# UNITED STATES PATENT AND TRADEMARK OFFICE

APPLICATION NO.	FILING DATE	FIRST NAMED INVENTOR	ATTORNEY DOCKET NO.	CONFIRMATION NO.
10/053,198	01/17/2002	Chinnugounder Senthilkumar	10559/649001/P12971	2860
20985	7590 05/23/2003			
	CHARDSON, PC LA VILLAGE DRIVE		EXAMI	NER
SUITE 500		SHINGLETON, MICHAI	MICHAEL B	
SAN DIEGO, CA 92122			ART UNIT	PAPER NUMBER
			2817	
			DATE MAILED: 05/23/2003

Application No. Applicant(s)					
Office Action Summary	10-053,198 Senthilkumar et al					
Office Action Summary	Group Art Unit					
	SHINGLETON Z817					
-The MAILING DATE of this communication appears of	on the cover sheet beneath the correspondence address—					
Period for Reply						
A SHORTENED STATUTORY PERIOD FOR REPLY IS SET TO OF THIS COMMUNICATION.	EXPIRE Three MONTH(S) FROM THE MAILING DATE					
<ul> <li>If the period for reply specified above is less than thirty (30) days, a repl</li> <li>If NO period for reply is specified above, such period shall, by default,</li> <li>Failure to reply within the set or extended period for reply will be extended.</li> </ul>	36(a). In no event, however, may a reply be timely filed after SIX (6) MONTHS by within the statutory minimum of thirty (30) da

Figure 3 and columns 3 and 4 of Jansson set forth an integrated crystal oscillator apparatus.

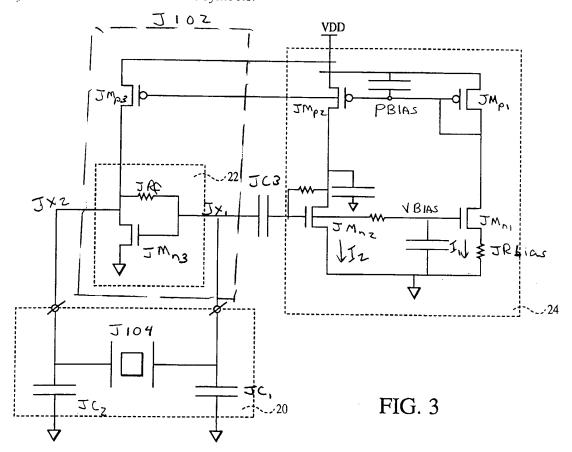
Jansson states: "FIG 3 is described in more detail in the Vittoz article". Thus in accordance with MPEP 2131.01, this 35 USC 102 rejection is based upon both Jansson and Vittoz. Vittoz merely helps explain the meaning of the referenced and unreferenced terminology used in the specification and drawings of Jansson and shows that the characteristics not disclosed in Jansson are inherent. Figure 3 of Jansson does not give reference numerals for each and every element in Figure 3. Therefore, in order for the following rejection to accurately point to item by item in the claims of the instant application and for applicant's case of understanding, the following copy of Figure 3 of Jansson is provided with reference symbols and this rejection refers to these reference symbols.

Note that while Figure 3 of Jansson is not clear on whether the line "PBIAS" directly connects to all the gates of JMp1, JMp2, and JMp3. It is clearly from Vittoz that such is the case.

Figure 3 of Jansson as evidenced by Vittoz discloses an "apparatus" having an oscillator circuit 1100 that is for generating "an oscillating signal" at the terminal JX1. This oscillator circuit 1100 has an inverting amplifier J102 and a resonator J104. The crystal resonator J104 has two terminals, JX1 and JX2, that are connected to input and output terminals, respectively, of inverting amplifier J102, as is clearly shown in Figure 3 of Jansson as evidenced by Vittoz (Also note page 4, lines 15-17 of the instant application and at least claim 2 of the instant application.). Jansson as evidenced by Vittoz also includes a feedback resistor JRf that feeds back a portion of the amplified oscillating signal to the input of the amplifier as clearly shown in Figure 3 of Jansson as evidenced by Vittoz. Jansson as evidenced by Vittoz also provides a "bias circuit" 24. Note this arrangement produces a relatively constant current II flowing through relatively constant current source JMp1 and JMn1, and a relatively constant current I2 flowing through relatively constant current source JMp2 and JMn2 because of the current mirror arrangement of these transistors (Also see Figure 9 of Vittoz). Since all of the structure of the bias circuit 106 of the instant invention is clearly present in Figure 3 of Jansson, the "relatively constant current source", noted above, is "configured to create a relatively constant bias voltage (PBIAS) to bias the amplifier in an operating state that can sustain the oscillating signal" as is inherent in Jansson as evidenced by Vittoz. While Jansson does not identify the operation region of the transistors of the bias circuit and the transistors of the inverting amplifier when an "operation state" is obtained, the transistors of Jansson as evidenced by Vittoz are operated in the weak inversion region when an "operation state" is obtained as evidenced by Vittoz. In particular note page 229 of Vittoz. The "weak inversion" region is also well known in the art as the "sub-threshold region". The relatively constant current source JMp1, JMn1, JMp2, and JMn2 has a first portion JMp1 and JMn1 that produces a relatively constant current I1 and a second portion JMp2 and JMn2 that produces a relatively constant current I2. The "first current" is II and the "second current" is I2. Because of the action of the current mirror arrangement of the transistors of Jansson as evidenced by Vittoz, Jansson as evidenced by Vittoz inherently produces a first current that is a substantially fixed ratio to the second current. Also because of the action of the current mirror arrangement of the transistors of Jansson as evidenced by Vittoz, Jansson as evidenced by Vittoz inherently provides the direct current bias voltage on the node "PBIAS" that is electrically connected to the inverting amplifier J102 as clearly shown in Figure 3 of Jansson and also because of this action of the current mirror arrangement of Jansson as evidenced by Vittoz this bias voltage has a "predefined" relationship with the current flowing through the first portion. The specification does not identify which

component provides for "negative feedback in response to a change in the amount of current flowing through the second portion", however, because Jansson as evidenced by Vittoz has all the same structure for what the examiner believes is the "second portion" (See the above lack of antecedent basis in the specification for this terminology.) one of these components inherently provides for "negative feedback in response to a change in the amount of current flowing through the second portion".

The apparatus of Jansson as evidenced by Vittoz is silent on the statement of intended use as presented in claims like base claim 1. Namely, claim 1 of the instant invention states in the preamble that the invention claimed is "for generating a clock signal". This appears only in the preamble of the claim and accordingly Jansson as evidenced by Vittoz is seen as anticipating the claimed invention. However, column 3, around line 56 of Jansson clearly recognizes the use of this oscillator in a digital watch. It is well known that a digital watch uses such an oscillator as a clocking mechanism to control the movement of the hands of the watch or the selection of the appropriate digit to be displayed. Thus the oscillator of Jansson as evidenced by Vittoz inherently generates a clock signal. All constant frequency oscillators inherently generate a "clock" signal. Since the clock oscillator of Jansson as evidenced by Vittoz generates its clock signal in "real time" the oscillator of Jansson as evidenced by Vittoz is a "real time clock oscillator circuit".

As noted above the relatively constant current source 24 of Jansson as evidenced by Vittoz produces a bias voltage PBIAS. This bias voltage is applied at the node where PBIAS is shown in the above Figure. Thus, Jansson as evidenced by Vittoz clearly includes a "bias node" PBIAS and the relatively constant current source 24 is configured to create the bias voltage PBIAS at the bias node PBIAS. As recognized by Jansson as evidenced by Vittoz the capacitor JC3 in combination with the transistors of element 24 and voltage source Vdd provides for an amplitude regulation during start-up and provides an excitation circuit as recognized specifically on page 229 of Vittoz. This excites the bias circuit to start operation and provide a stable bias voltage. Thus the capacitor JC3 in combination with the transistors of element 24 and the voltage source Vdd forms an "excitation circuit".

Specifically, Figure 3 and columns 3 and 4 of Jansson set forth an integrated crystal oscillator apparatus.

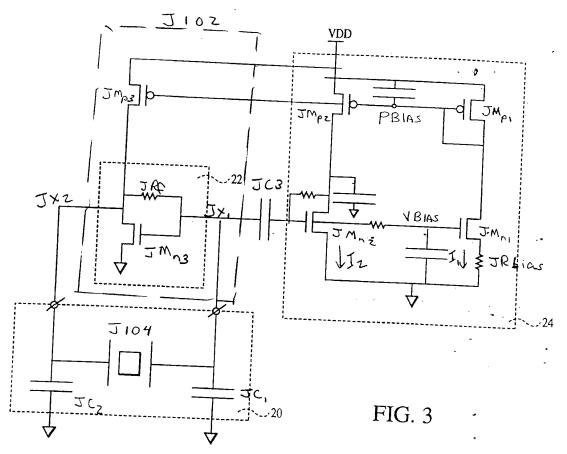
Jansson states: "FIG 3 is described in more detail in the Vittoz article". Thus in accordance with MPEP 2131.01, this 35 USC 102 rejection is based upon both Jansson and Vittoz. Vittoz merely helps explain the meaning of the referenced and unreferenced terminology used in the specification and drawings of Jansson and shows that the characteristics not disclosed in Jansson are inherent. Figure 3 of Jansson does not give reference numerals for each and every element in Figure 3. Therefore, in order for the following rejection to accurately point to item by item in the claims of the instant application and for applicant's ease of understanding, the following copy of Figure 3 of Jansson is provided with reference symbols and this rejection refers to these reference symbols.

Note that while Figure 3 of Jansson is not clear on whether the line "PBIAS" directly connects to all the gates of JMp1, JMp2, and JMp3. It is clearly from Vittoz that such is the case.

Figure 3 of Jansson as evidenced by Vittoz discloses an "apparatus" having an oscillator circuit J100 that is for generating "an oscillating signal" at the terminal JX1. This oscillator circuit J100 has an inverting amplifier J102 and a resonator J104. The crystal resonator J104 has two terminals, JX1 and JX2, that are connected to input and output terminals, respectively, of inverting amplifier J102, as is clearly shown in Figure 3 of Jansson as evidenced by Vittoz (Also note page 4, lines 15-17 of the instant application and at least claim 2 of the instant application.). Jansson as evidenced by Vittoz also includes a feedback resistor JRf that feeds back a portion of the amplified oscillating signal to the input of the amplifier as clearly shown in Figure 3 of Jansson as evidenced by Vittoz. Jansson as evidenced by Vittoz also provides a "bias circuit" 24. Note this arrangement produces a relatively constant current II flowing through relatively constant current source JMp1 and JMn1, and a relatively constant current I2 flowing through relatively constant current source JMp2 and JMn2 because of the current mirror arrangement of these transistors (Also see Figure 9 of Vittoz). Since all of the structure of the bias circuit 106 of the instant invention is clearly present in Figure 3 of Jansson, the "relatively constant current source", noted above, is "configured to create a relatively constant bias voltage (PBIAS) to bias the amplifier in an operating state that can sustain the oscillating signal" as is inherent in Jansson as evidenced by Vittoz. While Jansson does not identify the operation region of the transistors of the bias circuit and the transistors of the inverting amplifier when an "operation state" is obtained, the transistors of Jansson as evidenced by Vittoz are operated in the weak inversion region when an "operation state" is obtained as evidenced by Vittoz. In particular note page 229 of Vittoz. The "weak inversion" region is also well known in the art as the "sub-threshold region". The relatively constant current source JMp1, JMn1, JMp2, and JMn2 has a first portion JMp1 and JMn1 that produces a relatively constant current I1 and a second portion JMp2 and JMn2 that produces a relatively constant current 12. The "first current" is 11 and the "second current" is I2. Because of the action of the current mirror arrangement of the transistors of Jansson as evidenced by Vittoz, Jansson as evidenced by Vittoz inherently produces a first current that is a substantially fixed ratio to the second current. Also because of the action of the current mirror arrangement of the transistors of Jansson as evidenced by Vittoz, Jansson as evidenced by Vittoz

inherently provides the direct current bias voltage on the node "PBIAS" that is electrically connected to the inverting amplifier J102 as clearly shown in Figure 3 of Jansson and also because of this action of the current mirror arrangement of Jansson as evidenced by Vittoz this bias voltage has a "predefined" relationship with the current flowing through the first portion. The specification does not identify which component provides for "negative feedback in response to a change in the amount of current flowing through the second portion", however, because Jansson as evidenced by Vittoz has all the same structure for what the examiner believes is the "second portion" (See the above lack of antecedent basis in the specification for this terminology.) one of these components inherently provides for "negative feedback in response to a change in the amount of current flowing through the second portion".

As noted above the relatively constant current source 24 of Jansson as evidenced by Vittoz produces a bias voltage PBIAS. This bias voltage is applied at the node where PBIAS is shown in the above Figure. Thus, Jansson as evidenced by Vittoz clearly includes a "bias node" PBIAS and the relatively constant current source 24 is configured to create the bias voltage PBIAS at the bias node PBIAS. As recognized by Jansson as evidenced by Vittoz the capacitor JC3 in combination with the transistors of element 24 and voltage source Vdd provides for an amplitude regulation during start-up and provides an excitation circuit as recognized specifically on page 229 of Vittoz. This excites the bias circuit to start operation and provide a stable bias voltage. Thus the capacitor JC3 in combination with the transistors of element 24 and the voltage source Vdd forms an "excitation circuit".
